## Access Report

Proposed Childcare Centre  
27 Steam Street  
MAITLAND NSW 2320

For: Brown Commercial Building  
Ref: PAA\_25163

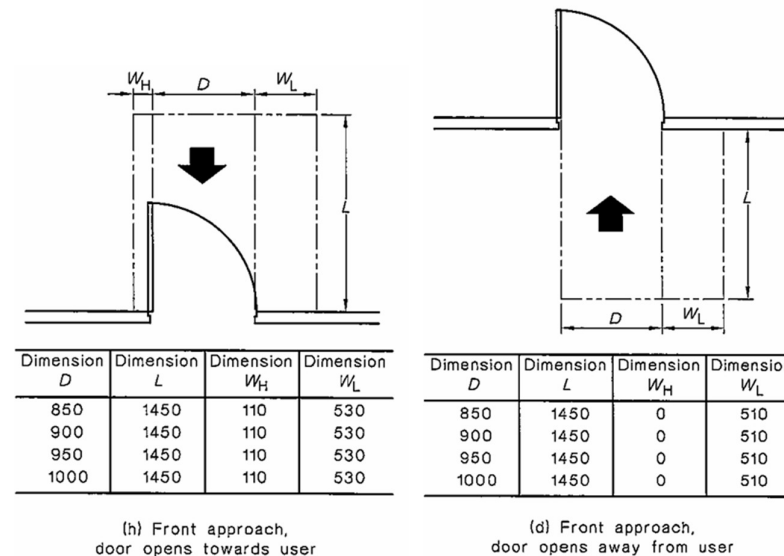
An accessible path of travel is provided to the building entrance from the allotment boundary along Steam Street via a formed footpath and a 1:20 gradient walkway.

Sufficient wheelchair clearance is provided at the base of the walkway to facilitate a 90 degree wheelchair turn. Ensure during detailed design that a clear 1500 x 1500mm turning space is maintained.

A hinged gate is at the top of the walkway and required clearances are capable of being provided. Ensure during detailed design that the gate provides a minimum clear opening width of 850mm and the following clearances are provided either side of the gate opening.

Ensure that a wall or kerb is provided to the walkway edges in accordance with Figure 18 and 19 of AS1428.1. The kerb cannot be within the clearances required to the door.

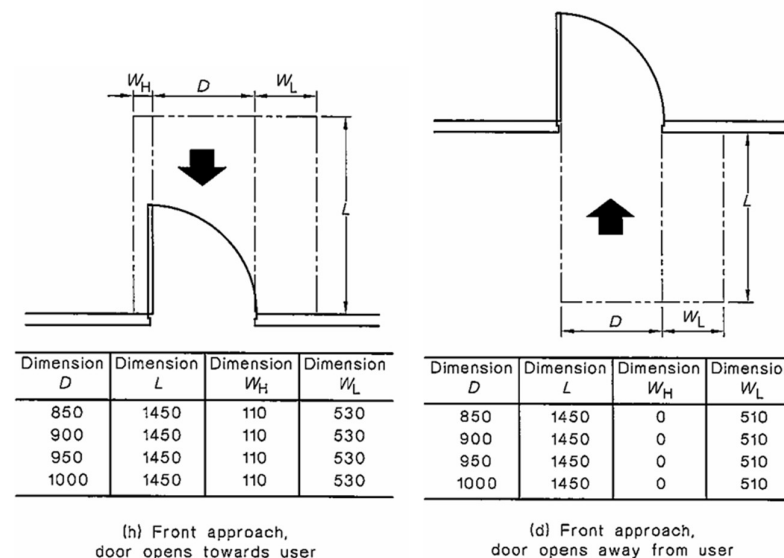
Ensure that a wall or kerb is provided to the walkway edges in accordance with Figure 18 and 19 of AS1428.1. The kerb cannot be within the clearances required to the gate.
